**Request for Additional Information No. 385(4524, 4515), DRAFT
Questions 09.01.04-15, 09.01.04-16 and 09.01.04-17**

QUESTIONS for Balance of Plant Branch 1 (AP1000/EPR Projects) (SBPA)

Question 09.01.04-15:**Follow-up to RAI 131, Questions 09.01.04-5 and 09.01.04-7**

Figure 9.1.2-9—Cask Loading Pit Gates

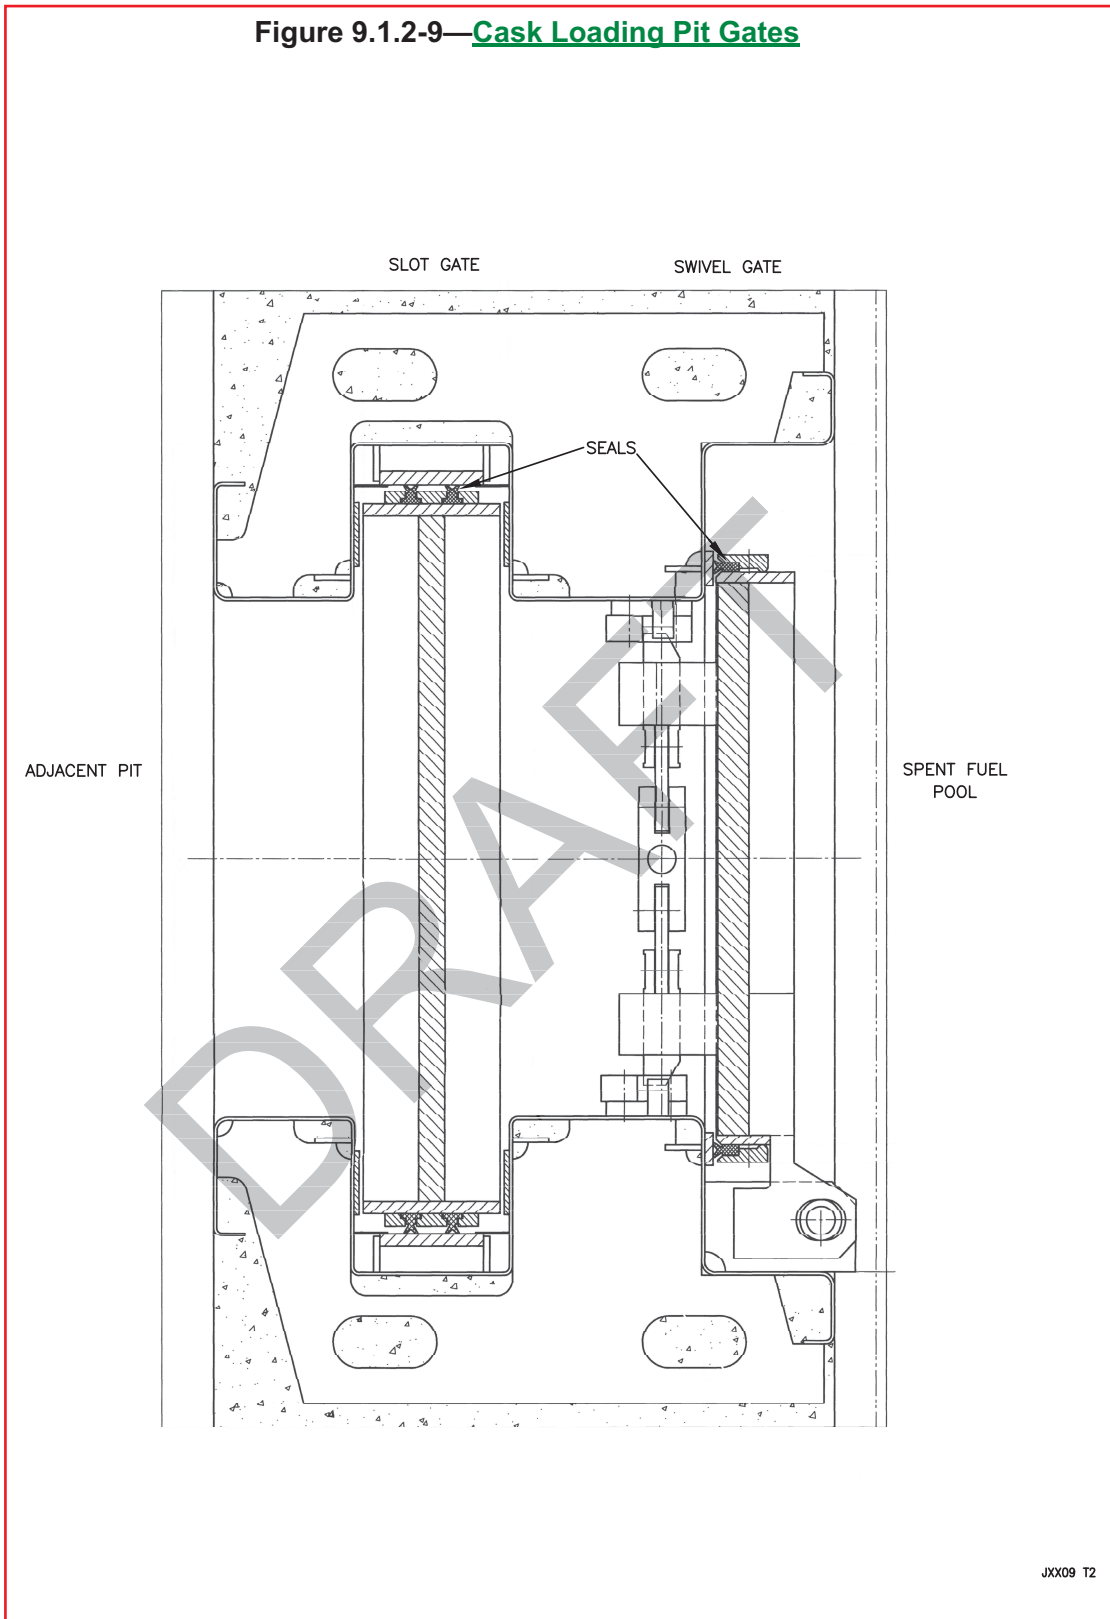
In RAI 9.1.4-7, the staff asked the applicant to provide the methodology for preventing draining of the SFP, when the shipping cask is connected to the bottom of the cask loading pit, assuming a single failure. The response to RAI 9.1.4-7 proposed a markup indicating that the gates and weirs are arranged so that the bottoms of the gates are higher than the top of the stored fuel assemblies.

The cask loading pit should include a system for detecting and containing pool liner leaks. Segmented leak channels, proper drainage, and sumps for collecting and containing such leakage should be used. Provide, in the FSAR, the details of the system to be used to detect and collect leakage from the cask loading pit and the penetration at base of the cask loading pit. Provide, in the FSAR, the details of system to be used to detect and collect leakage while the cask loading pit penetration is closed and during cask loading operation.

Two stainless steel gates separate the cask loading pit from the SFP and two stainless steel gates separate the transfer compartment from the SFP. Figure 9.1.2-9—Cask Loading Pit Gates shows the cask loading pit gates. The gates allow isolation of the

The two gates separating the spent fuel pool from the cask loading pit are described in Section 9.1.2.2.2. The gates do not rely on active equipment, such as inflatable seals, to maintain leak-tightness. The slot gate seals are compressed by the weight of the gate to create a leak tight barrier. The swivel gate has a locking mechanism which equally distributes pressure on the seal to create a leak tight barrier. The swivel gate is locked in both the open and closed positions. The gates are shown in Figure 9.2.1-9 - Cask Loading Pit Gates. Unless spent fuel is being moved to the cask loading pit, both gates are closed. Failure of a single gate does not impact the water inventory in the spent fuel pool. During cask loading operations, the slot gate is removed, and the swivel gate is open to allow fuel movement into the cask loading pit.
